MS Reference Number:	CSHK	CET	MS	C	2024	000115
ACC Reference Number:	1701	W	000	CSC	760	000155

METHOD STATEMENT TITLE	Rev. C
Method Statement for Installation of Sheet Piles for the Temporary Underfloor Wheel Lathe

**Document Title:** Method Statement for Excavation and Lateral Support for the Temporary Underfloor Wheel Lathe  
**Document Revision:** 22-Feb-24  
**Deadline:** 28-May-24

Figure 7.6.4: Showing the Height of Sheet Piles Of Each Location.

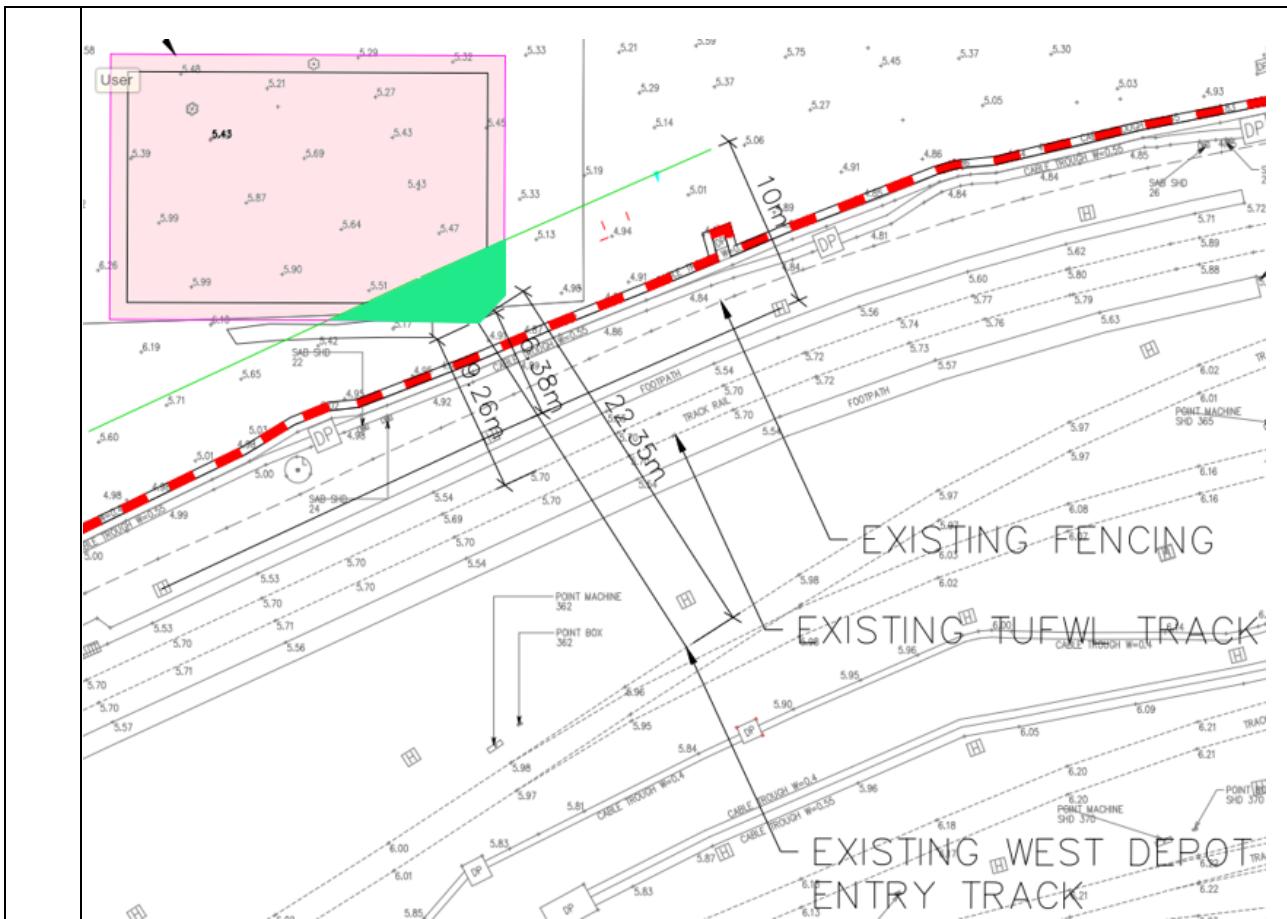
38	Yu Sir		1. Figure 7.6.2 on page 21 of 47 : Please mark up the 10m line (10m from the adjacent OHL/live track) on the plan.	<p>Noted. The 10m line is marked in Figure 7.6.2 for your reference.</p> <p>Figure 7.6.2: Showing the Height Of Sheet Piles Of Each Location.</p>
39	Yu Sir		1. Figure 7.7.3 & &7.4 on Page 24 of 47 :- The mentioned 29m distance is misleading. The closet distance between silent piling machine and the OHL Posts shall be measured from the SOP03.	This figure mainly responds to Rtc No.5 regarding the setup location of the silent piling machine. For the entire sheet piling installation works, the silent piling machine can handle the corner works without requiring any lifting during the installation of the corner sheet pile. Therefore, there is only one designated setup location, SOP01, which aligns with figures 7.7.3 and 7.7.4.

Figure 7.7.1: Installation of Sheet Pile Stage from Phase 1 to Phase 4 indicated in figure above. The green lines identified the 10m area from the adjacent OHL or live track

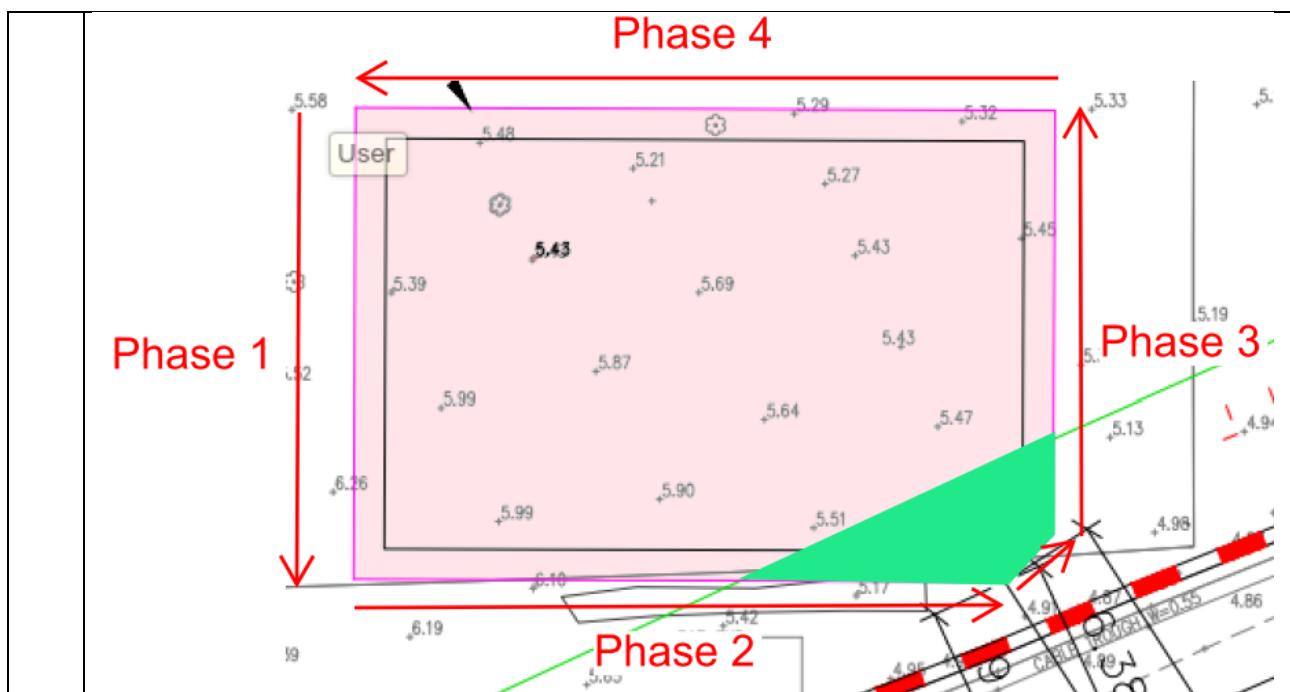
<p>Pls consider amending 1701 Permit-to-Dig system accordingly. Kindly clearly state the reasons why the changes are considered inapplicable otherwise.</p>	The safe distance during excavation by using machinery should be addressed on the permit to dig.	The types of machinery and excavation methods should be specified on the permit-to-dig and the allowed operation area should be demarcated on site	Appoint a designated engineer to approve the permit-to-dig. <b>Specific training should be provided to the responsible engineer for briefing on the permit-to-dig issuance procedure.</b>	The permit-to-dig should countersign by the designated engineer after verifying the accuracy of the permit-to-dig and the information in UU report. Work can only commence after approval from the designated engineer.	<b>The responsible engineer should participate in the briefing for the permit-to-dig to explain the planned excavation method and sequence.</b>	<p>Permit-to-Dig system was updated and attached in Appendix K for your reference.</p> <p>The permit to dig is issued by the Site Agent or Construction Manager. He/She is responsible to brief the Engineer for the underground utilities in the area in the Permit to Dig. The Engineer will brief the plant operators and workers in a training and sign on the Permit to Dig for record. A Chinese version method statement and layout plan will be also presented in the briefing section.</p>
The safe distance during excavation by using machinery should be addressed on the permit to dig.									
The types of machinery and excavation methods should be specified on the permit-to-dig and the allowed operation area should be demarcated on site									
Appoint a designated engineer to approve the permit-to-dig. <b>Specific training should be provided to the responsible engineer for briefing on the permit-to-dig issuance procedure.</b>									
The permit-to-dig should countersign by the designated engineer after verifying the accuracy of the permit-to-dig and the information in UU report. Work can only commence after approval from the designated engineer.									
<b>The responsible engineer should participate in the briefing for the permit-to-dig to explain the planned excavation method and sequence.</b>									
3	RP	-	Please find my comments which are marked in Red in the attached returned file. (refer to Yu Sir email)	The comments are addressed and attached in the email for your reference.					
4	RP	-	<p>Figure 7.1.1 refers, please provide a layout plan showing the clearance between the sheet pile and railway facilities to justify the extent of 5m height sheet pile.</p>	<p>The figure 7.7.1 is updated to show the minimum extend of maximum 5m height sheet pile for your reference.</p>

**Figure 7.7.3: Plan view showing the Distance between the silent piling machine set up location and one of the closest OHL posts are around 29 meters.**

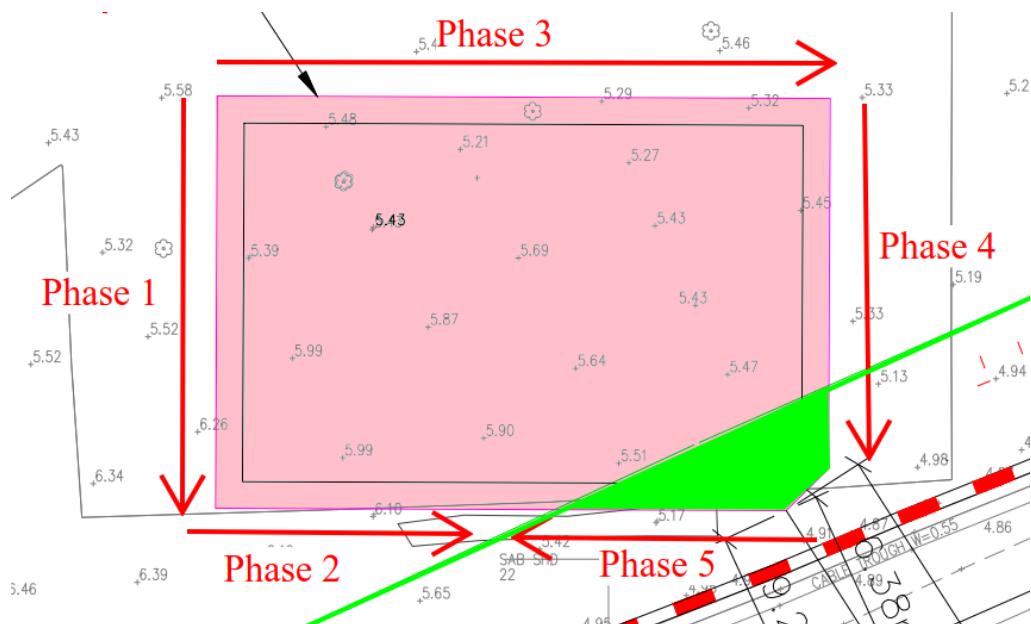
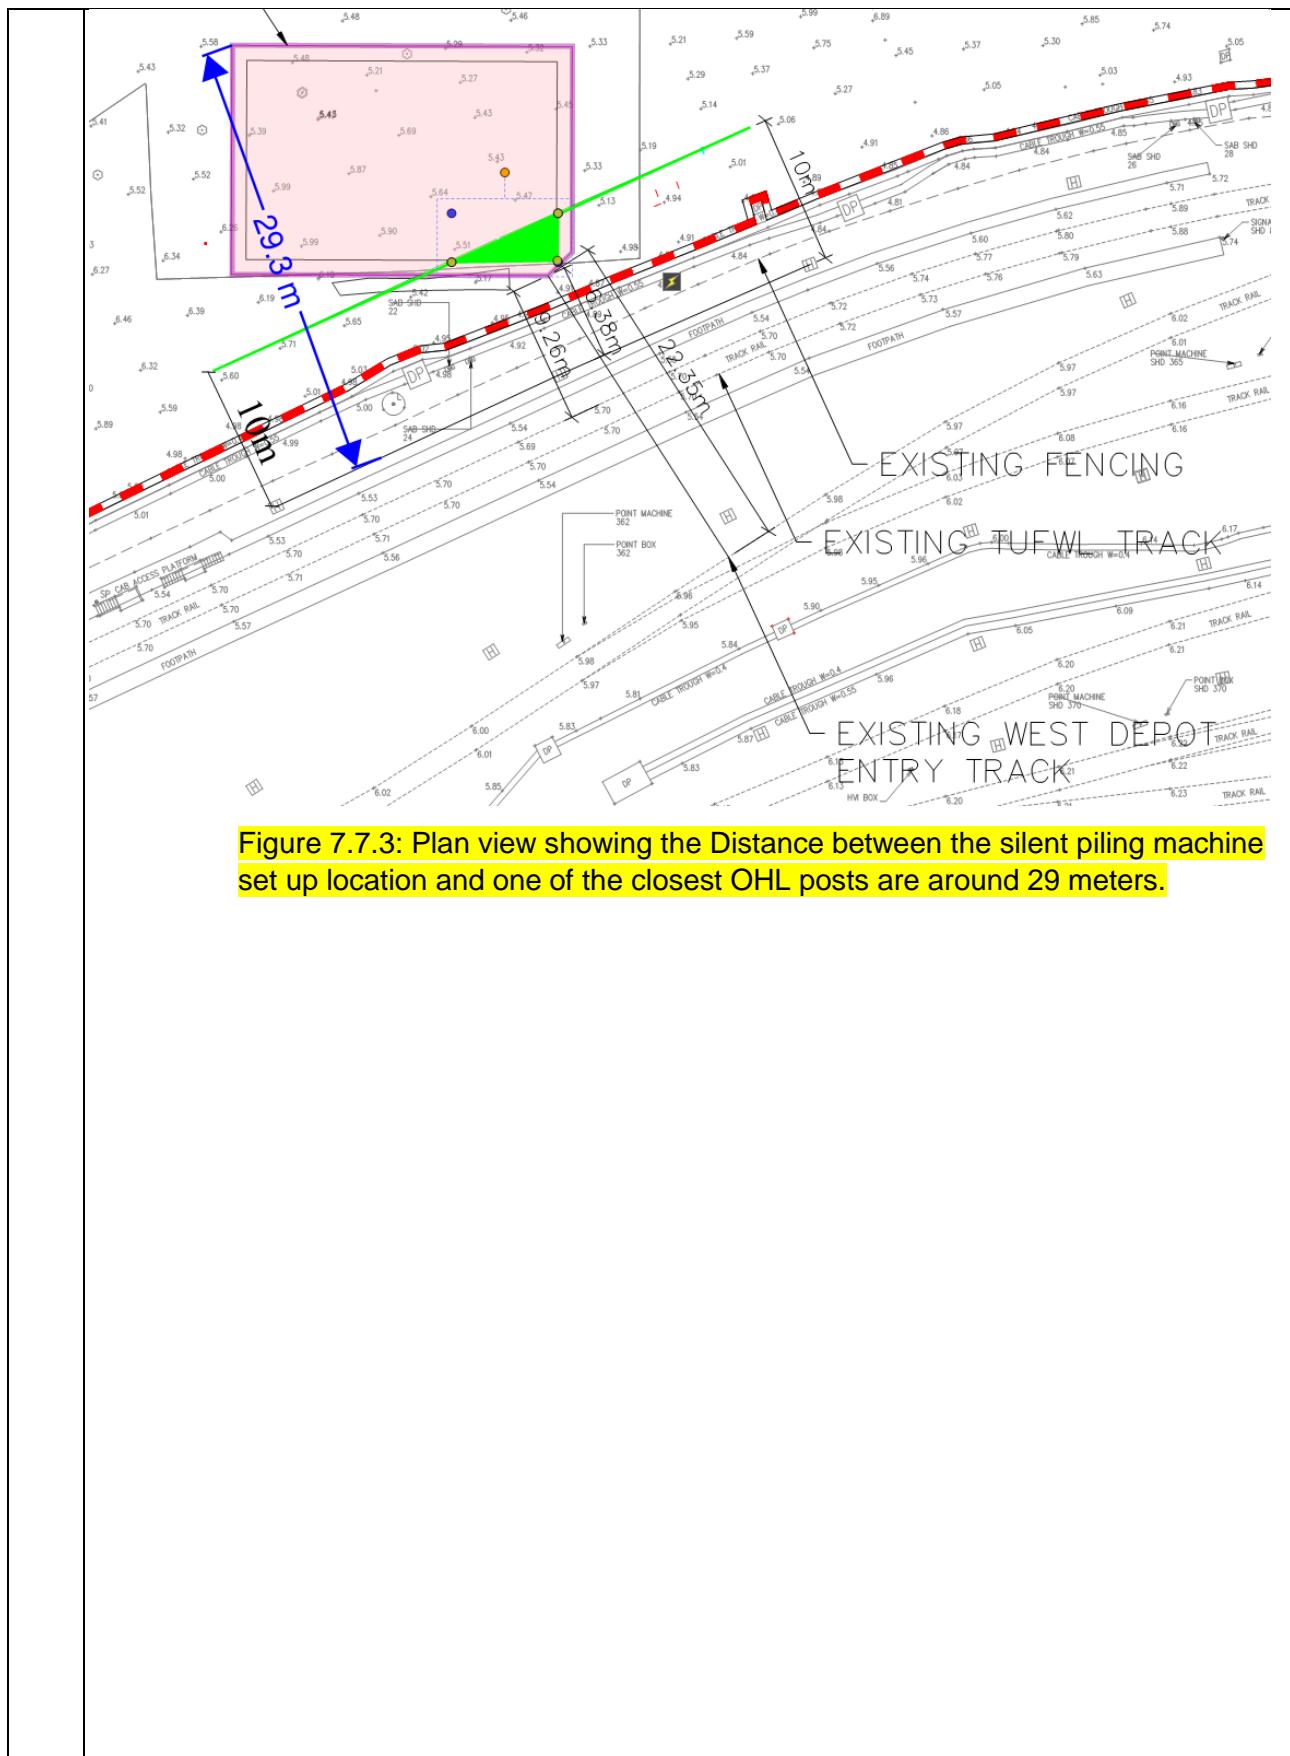
The setup location of the silent piling machine and the relationship between the railway facilities shall be considered.	The setup location is around 29m, which is a screenshot captured in the Navisworks model and attached in Figure 7.7.3 for your reference. 						
5 RP	-		PA works shall be applied when the sheet pile location was 10m measure from the railway facilities.	Noted. PA works will be input in ETMS system before commencement of work within 10m from the railway facilities if necessary. This sentence also added to section 7.7 Step 3 for clarification of the works.						
6 RP	-			<p><b>3. Crane lorry lifting chart and the corresponding Safe Working Load (SWL) (WITHIN 10M ZONE FROM OHL POST)</b></p> <table border="1"> <thead> <tr> <th>Lifting Item No.</th> <th>Lifting Objective Description</th> <th>Weight (T)</th> </tr> </thead> <tbody> <tr> <td>1</td> <td>Sheet Pile</td> <td>0.3 ton</td> </tr> </tbody> </table> <p><b>Lifting Plan for Lifting a Type 3 Sheet Pile 5m</b> MODEL: F990RA.2.28 (FASSI, ITALY) BOOM LENGTH: 19.85m WORKING RADIUS: 9.65m @ S.W.L.=7.715T WEIGHT OF LIFTING OBJECT: 0.3T (CRITICAL CASE) WEIGHT OF LA/LG: 0.3T TOTAL WEIGHT: 0.3+0.3=0.6T LIFTING CAPACITY: 0.6T/7.715T=8%</p> 	Lifting Item No.	Lifting Objective Description	Weight (T)	1	Sheet Pile	0.3 ton
